**CITY OF GAINESVILLE PLANNING DIVISION
SUMMARY OF COMMENTS**

Petition Number 8SUB-02 DB	Development Review Board
Review Date 5/09/02	Reviewed By Carolyn R. Morgan
Project Name/Description	Blues Creek Subdivision Unit 6-G

Petition No. 8SUB-02DB	Date Plan Rec'd: 4/30/02	Review Type: Stage II Preliminary Plat and Plan Review (Design Plat)
Review For: Development Review Board	Review Date: 5/16/02	Project Planner: Carolyn Morgan

BLUES CREEK UNIT- 6G

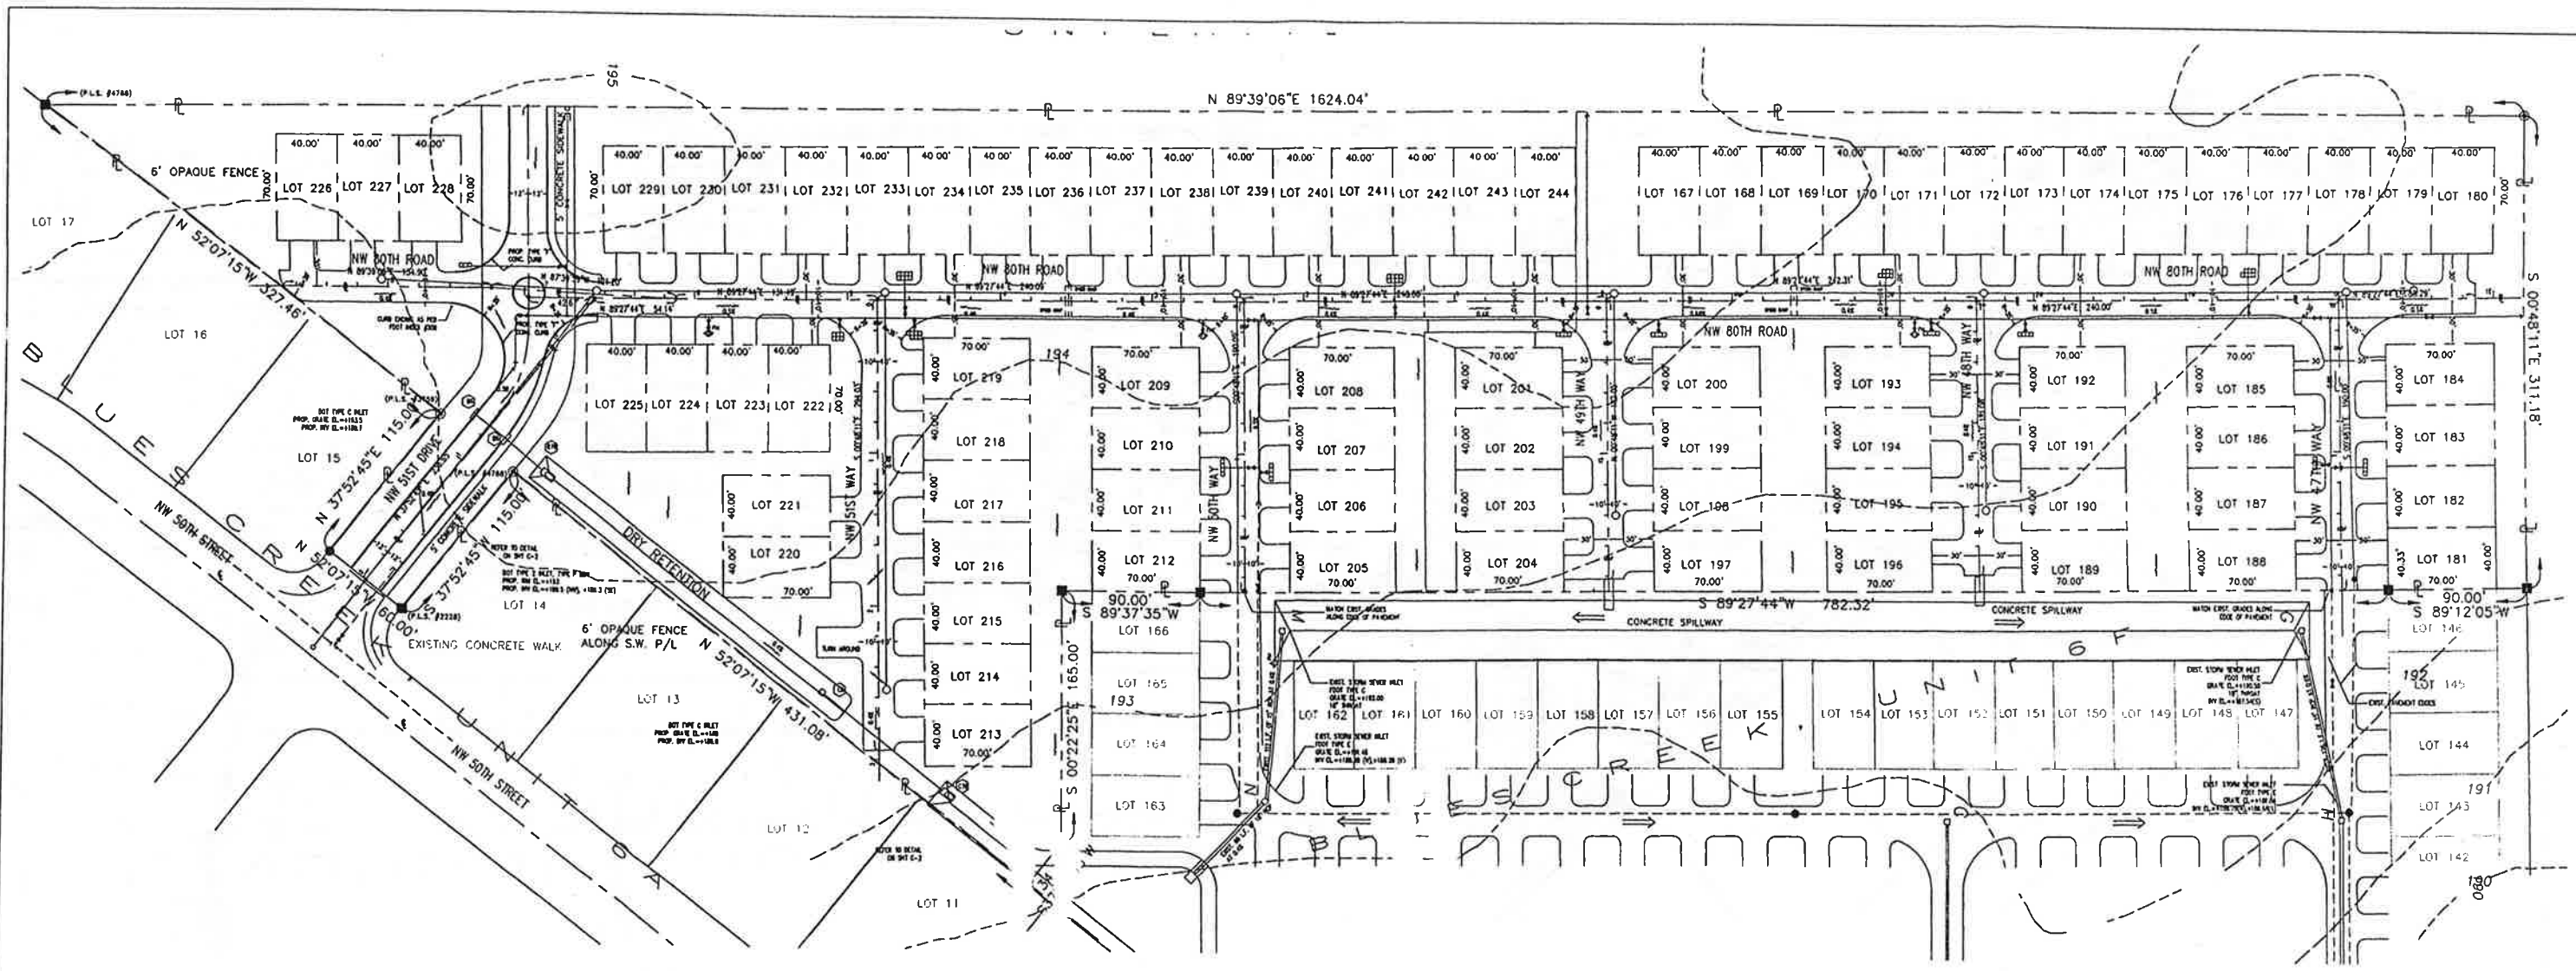
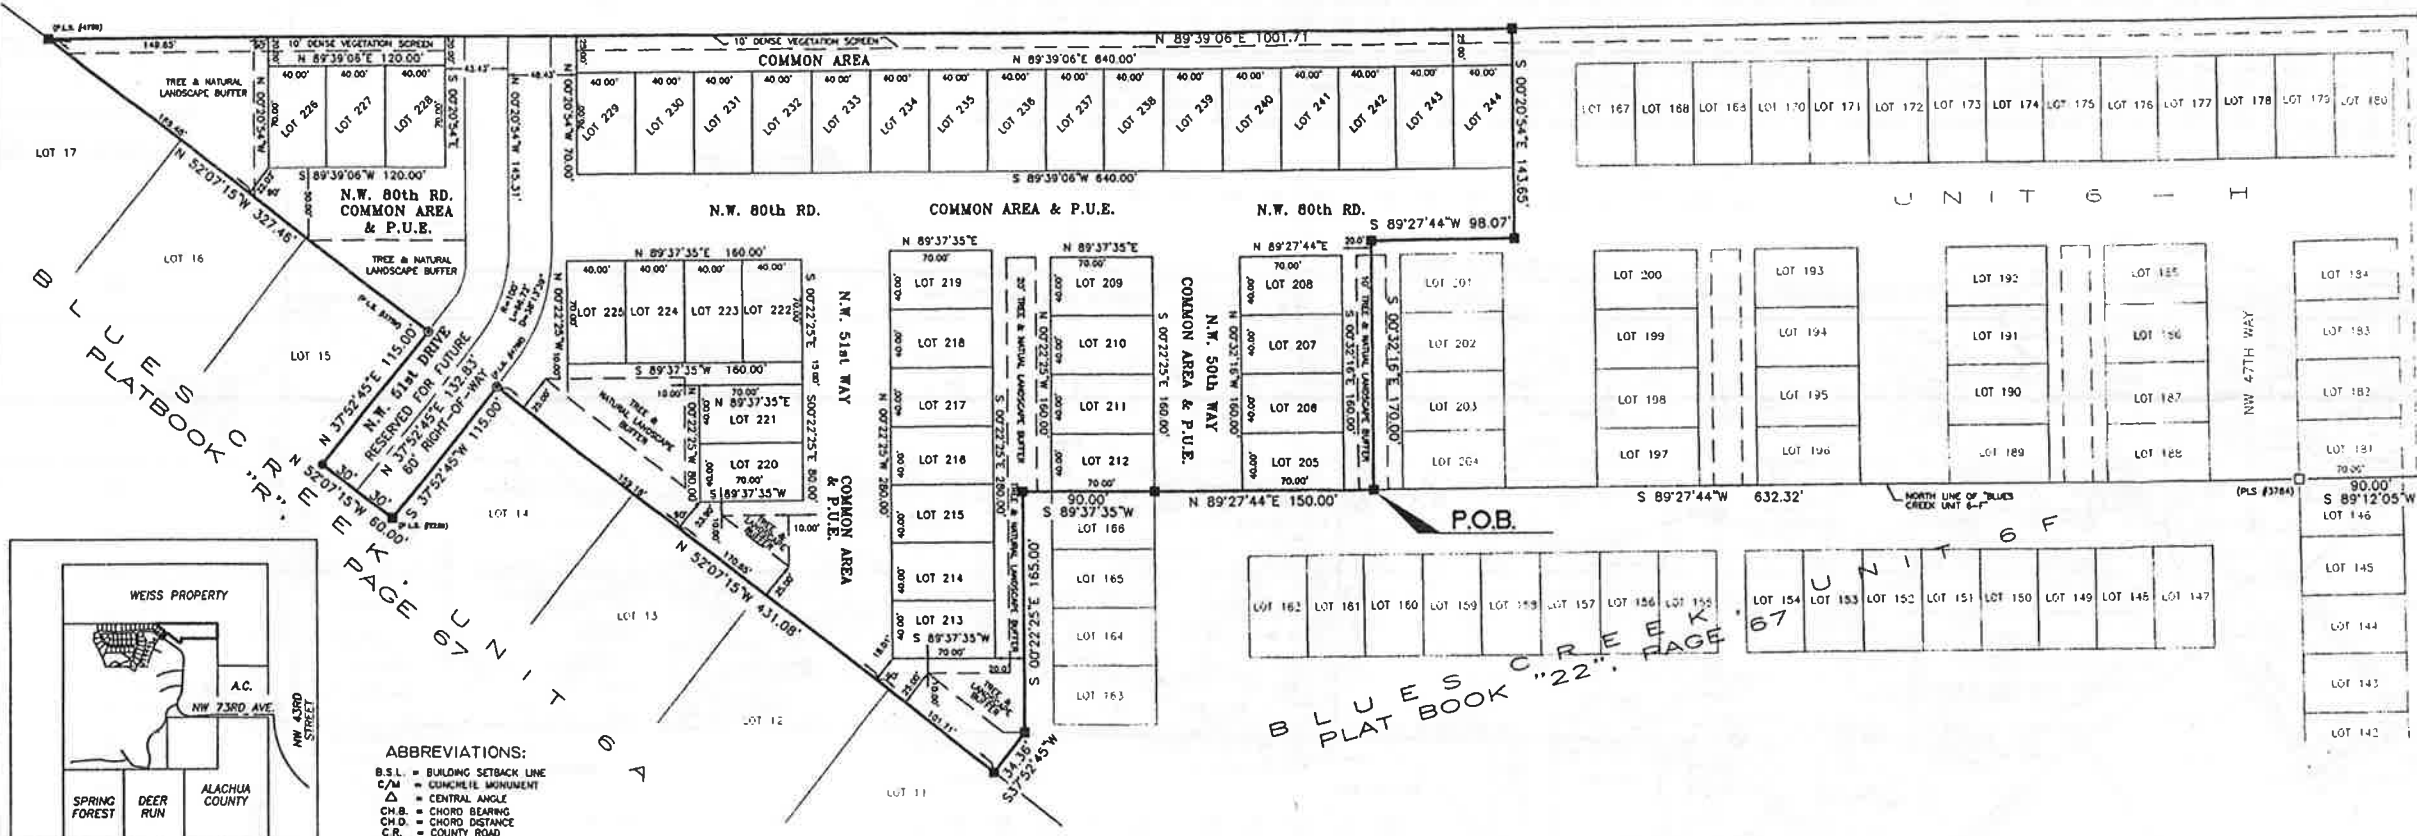
1. It does not appear that adequate buffer can be provided in the vicinity of Lots 213 and 226. Please eliminate these lots from the design plat.
2. A minimum of seven feet of at-grade berm should be provided between stormwater conveyance swale and any property line.
3. Please provide detail of proposed traffic calming.

Unit 6-A, what buffers are to be provided so that headlights at this point did not disturb existing houses.” She noted that lots 12 and 16 of Blues Creek Unit 6-A were abutting lots 213 and 226 of Blues Creek Unit 6-G. She indicated that she did not state that they should remove the two lots, but she believed the buffer was inadequate and she left it to the petitioner to show how they were going to deal with the concerns.

Mr. Higman indicated that he was still concerned about the issue of the encroachment of the driveways. He suggested that the board vote for staff's recommendation to remove the two lots with the idea that the conflict would be resolved.

<u>Motion By:</u> Mr. Higman	<u>Seconded By:</u> Mr. Borden
<u>Moved To:</u> Approve Petition 8SUB-02 DB with staff recommendations and the understanding that the petitioner will work with staff to redesign lots 213 and 226 to provide adequate buffer, or remove the lots if such buffer cannot be provided.	<u>Upon Vote:</u> Motion Carried 6-0 Yeas: Houston, Borden, Boyes, Cooper, Polopolus, Higman

C-1
DRAWING NUMBER:
101928-P01.DWG

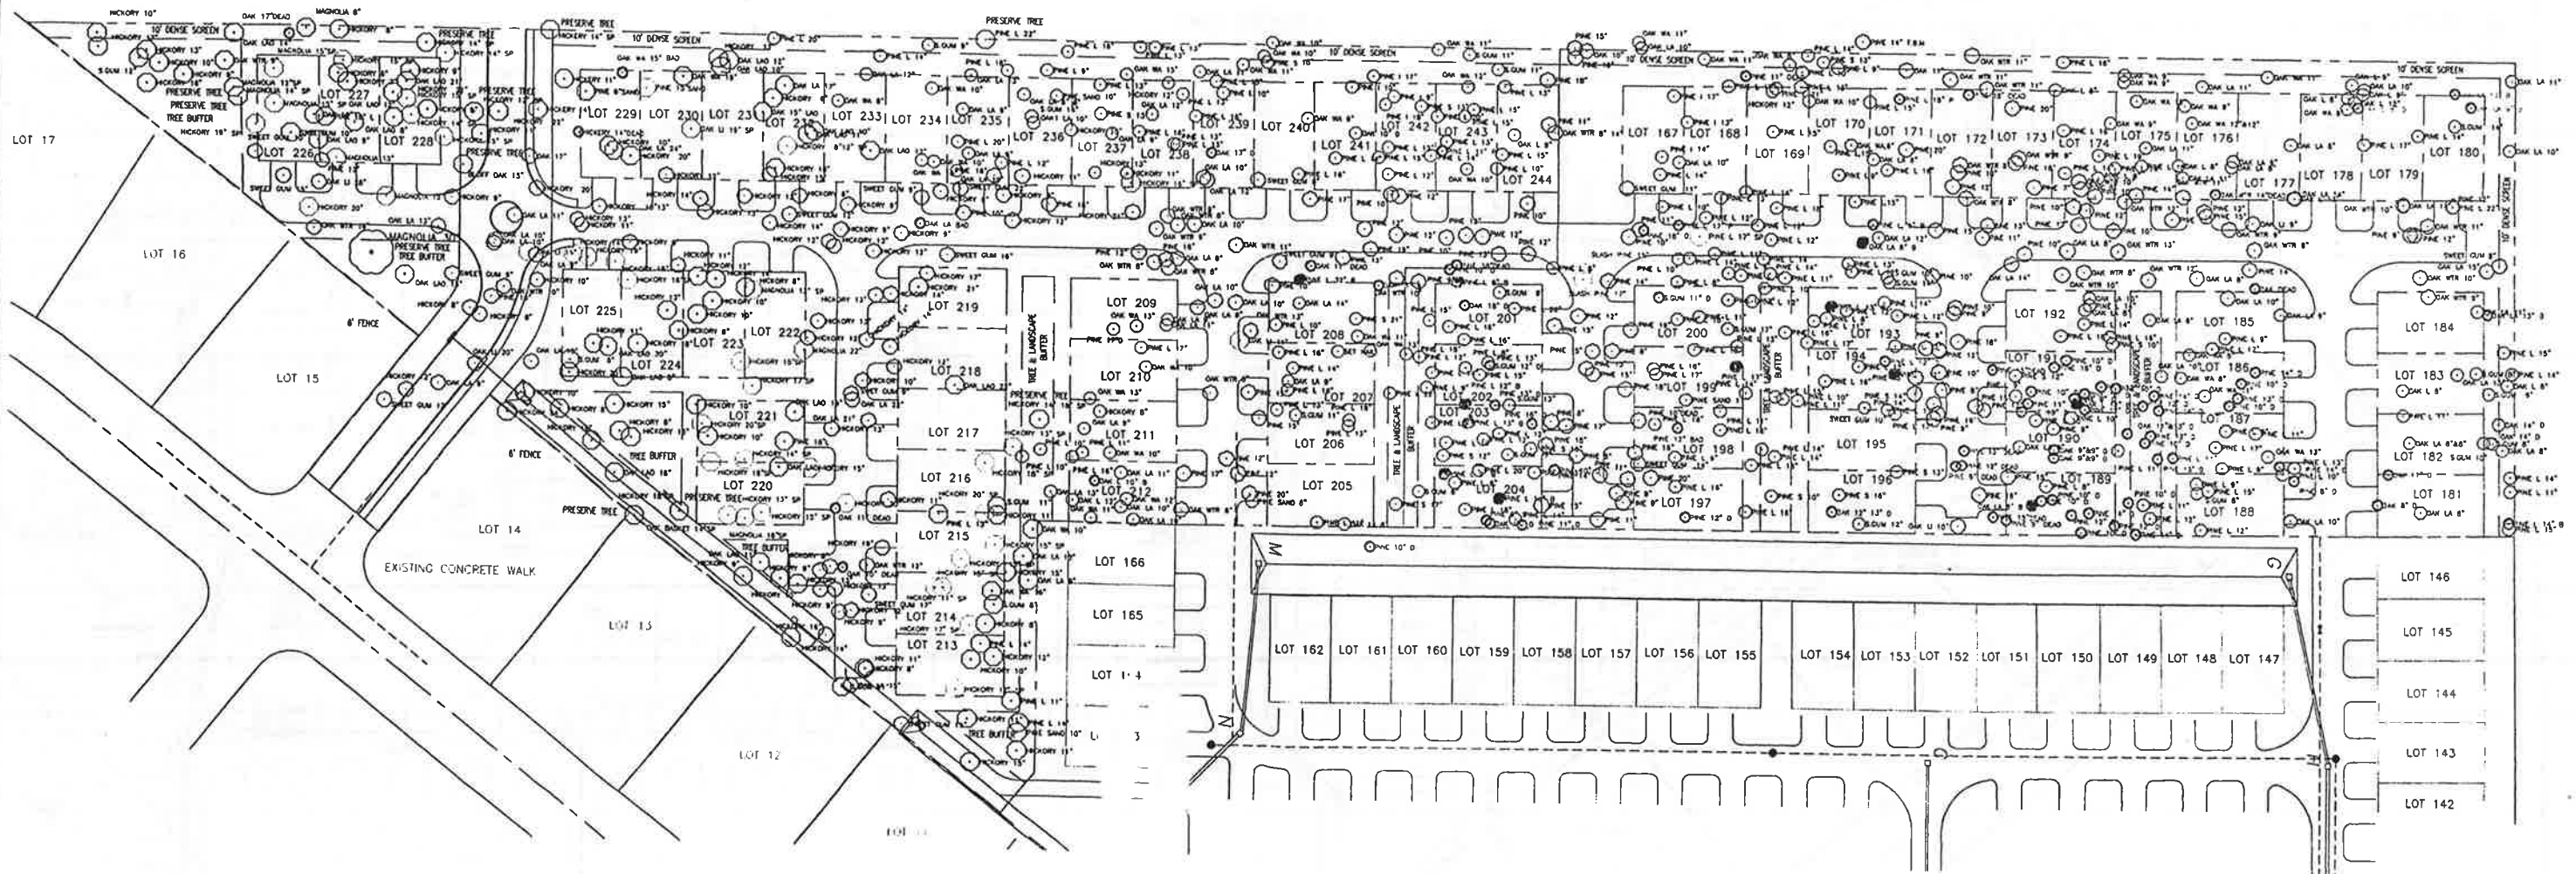
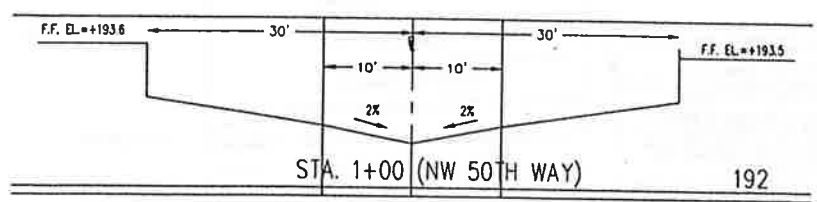
- Put the 11 regulated trees to be preserved on the site plan C-1 (not the site plan showing trees. C-1B).
- Show tree barricades drawn to scale around the trees to be preserved.
- Show barricades around the areas that were labeled as "dense vegetated screen" to keep the soil from getting compacted during construction. The barricades can be removed to work in the area and then can be put back up. This method of working will maintain a friable soil appropriate for supporting vegetation.
- Add the comment to the General Notes:
 "Trees will be preserved on site whenever possible. See the specifications for tree barricades on page ____ . Before beginning any site work, the tree barricades must be inspected and approved by the Parks Division (334-2171.)"
- Put the barricade information alluded to in the preceding comment on the appropriate

--On page C-1 include comment: "The site work contractor is responsible for either keeping all lime rock and construction debris out of planting areas. If lime rock is removed and make-up soil is required, it shall be clean deep fill with pH 5.5 - 6.5."
